## **Errata Sheet for the U.S. Ponderosa Road / South Shingle Springs Road Interchange Improvements Project Initial Study/Mitigated Negative Declaration**

EXHIBIT A to Errata Sheet for the U.S. Highway 50 / Ponderosa Road/South Shingle Springs Road Interchange Improvements Project Initial Study/Mitigated Negative Declaration

03-ED-50, PM 8.3/8.9  
(EA 03-2E550) – Project Number 0300000352

Design Standard Decision Document

**MOTHER LODE DRIVE  
TURN LANE CONFIGURATION  
SCALE : 1" = 40'**

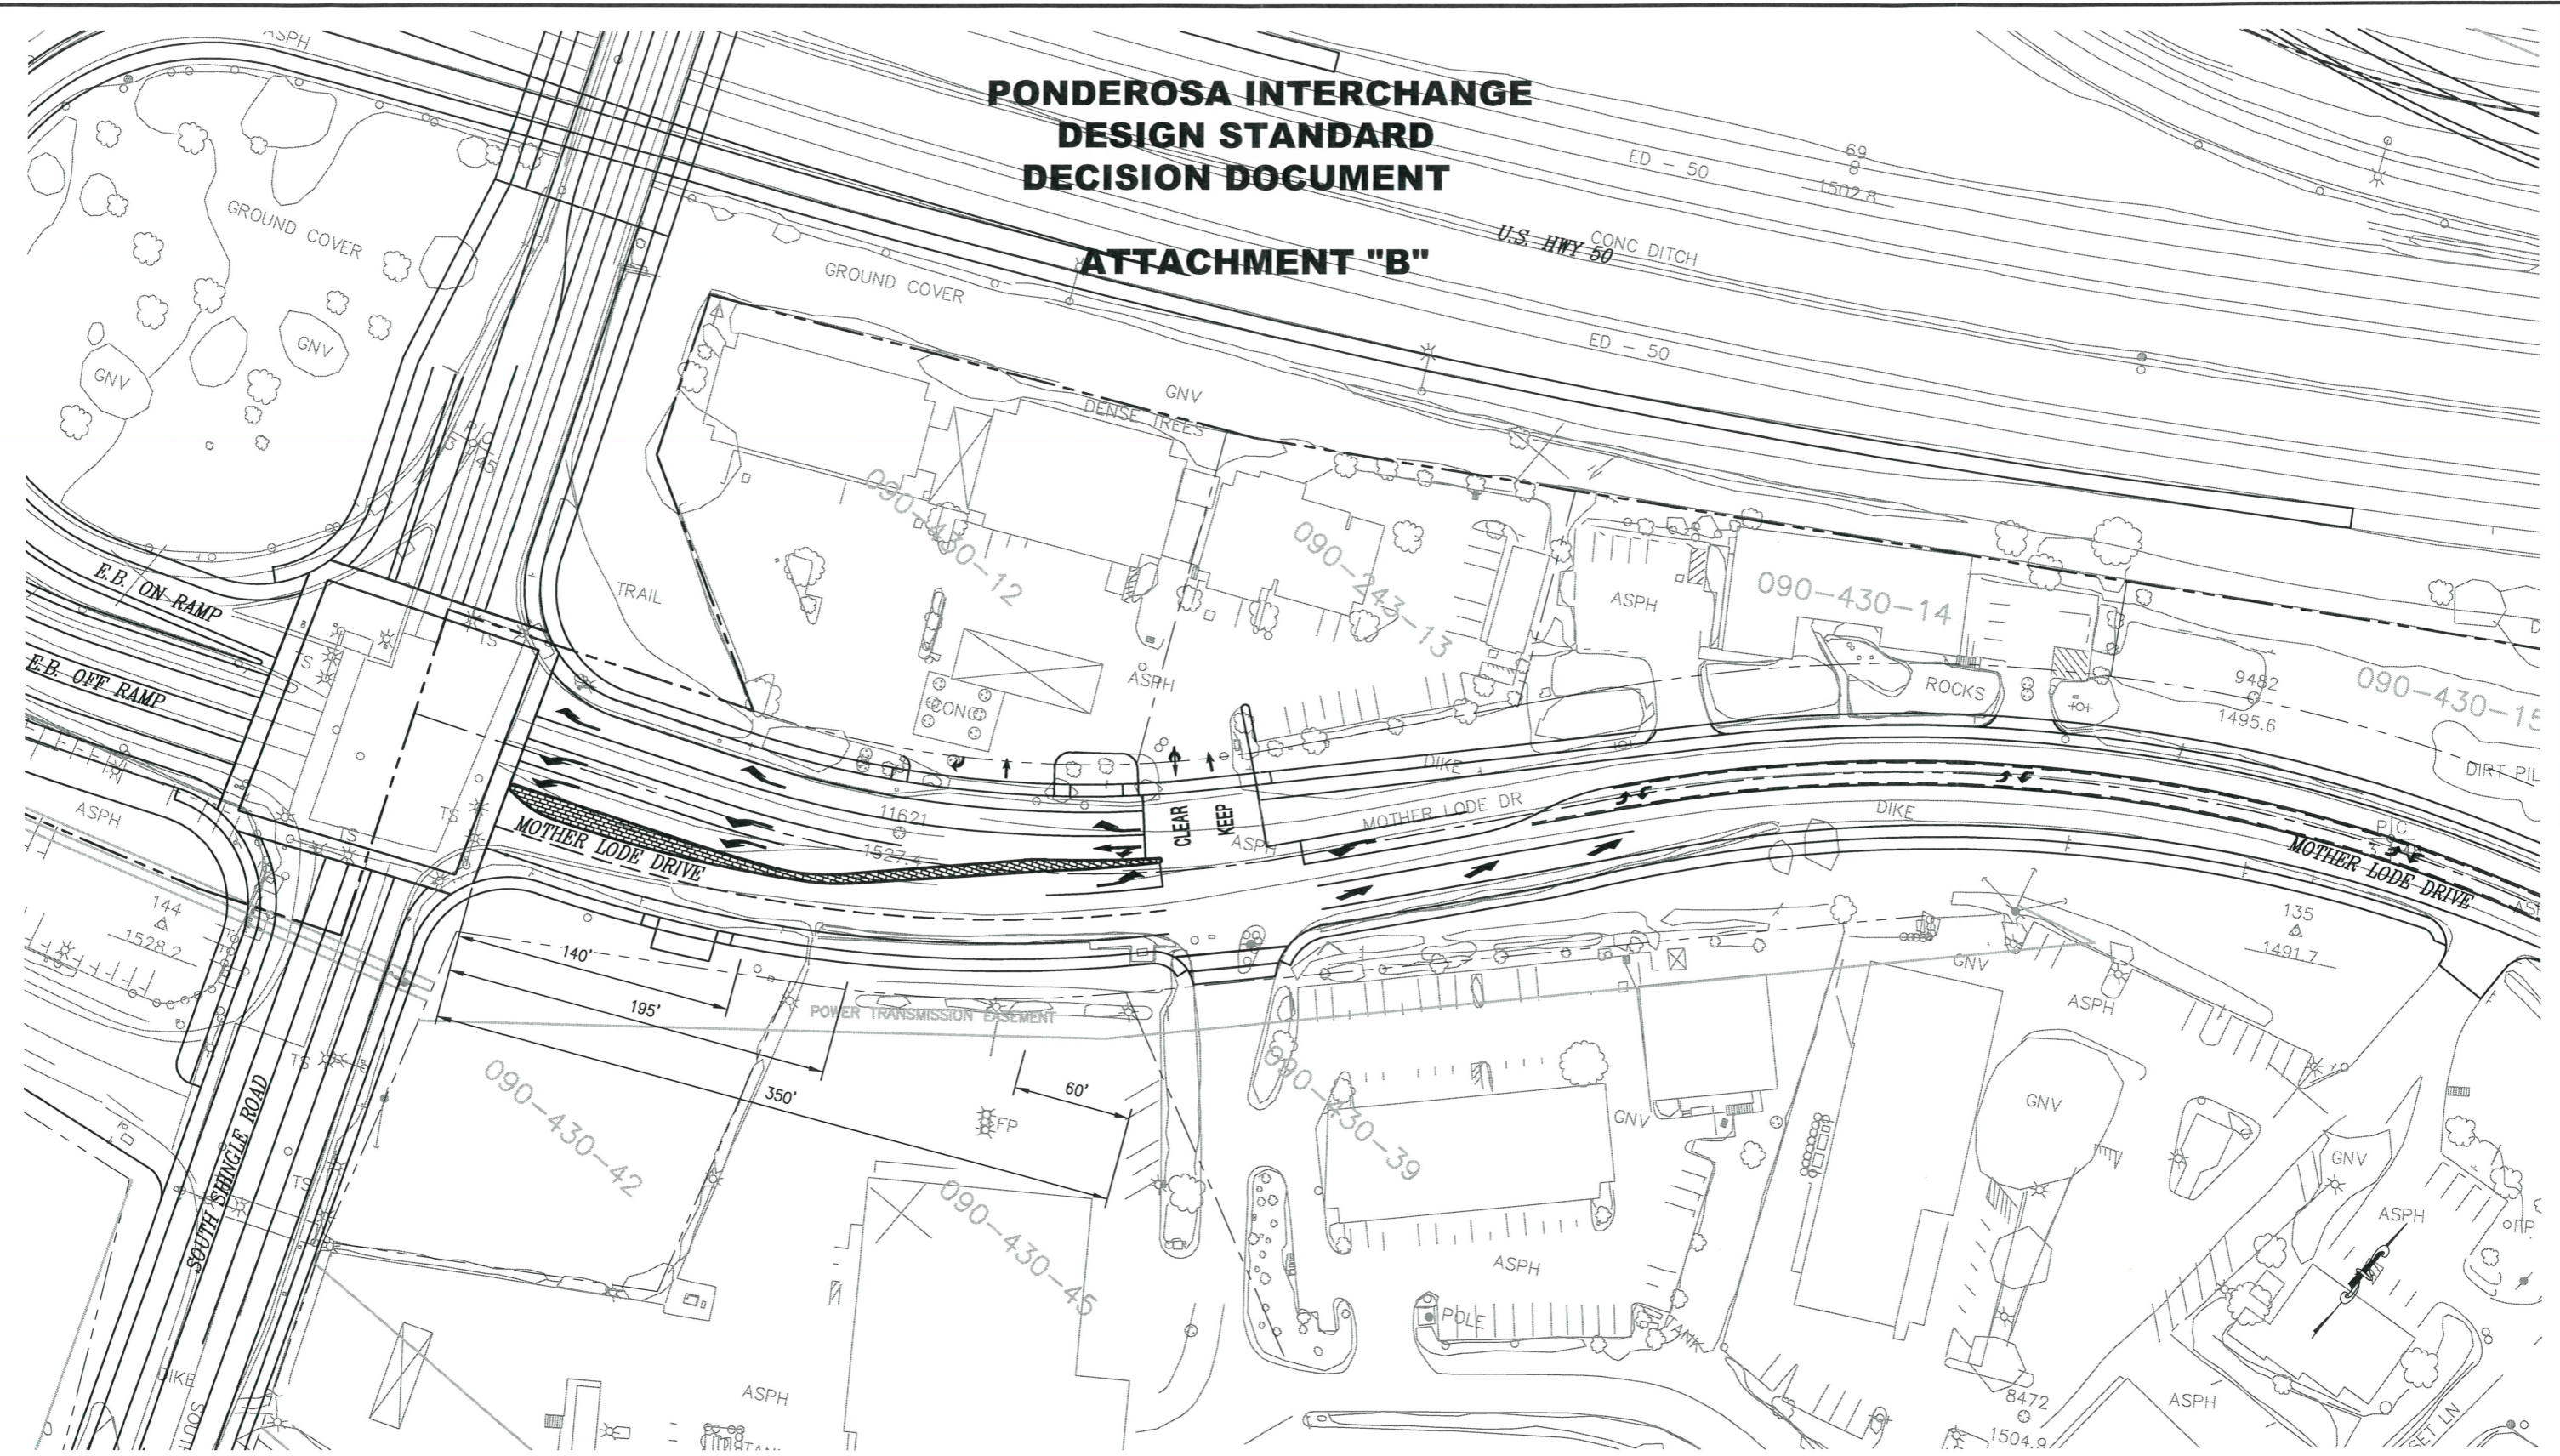
The proposed project proposes to allow full access to APN 090-430-12 and 090-243-13. The intersection would be located 350 feet northeast from the intersection of US-50 Eastbound Off-Ramp / South Shingle Road / Mother Lode Drive along Mother Lode Drive.

Section 504.3(3) of the 2018 Highway Design Manual (HDM) states: **“The minimum distance (curb return to curb return) between ramp intersection and local road intersections shall be 400 feet.”**

The existing driveway along Mother Lode Drive does not meet the current intersection spacing standard referenced. The existing non-standard driveway intersection is approximately 200 feet from the US-50 Eastbound Off-Ramp intersection. There is also a second driveway that is located approximately 350 feet from the Off-Ramp intersection. Both existing driveways currently have no restrictive movements and have full access. The Project is located within a fully developed commercial district which makes compliance with spacing standards more complex and challenging due to the existing conditions. The County has explored several options to make the intersection spacing meet standard, however the resulting impacts to property owners do not justify the improvements.

1. The first driveway that is located approximately 200 feet from the intersection will be restricted to right-in and right-out movements only. A center raised median along Mother Lode Drive will be installed to prevent left turn movements in and out of this driveway.
2. The second driveway that is located approximately 350 feet from the intersection will be the primary access point for the two parcels. Keep clear pavement markings will be used in front of the driveway to help prevent any potential storage que backups from the light at the intersection.
3. A turn pocket has been provided for cars traveling eastbound on Mother Lode Drive looking to turn into the development.

4. Revisions to the PSR GAD's were made to allow for dual left turn lanes for southbound Mother Lode Drive at the intersection. This will increase storage capacity and minimize blocking of the driveway.
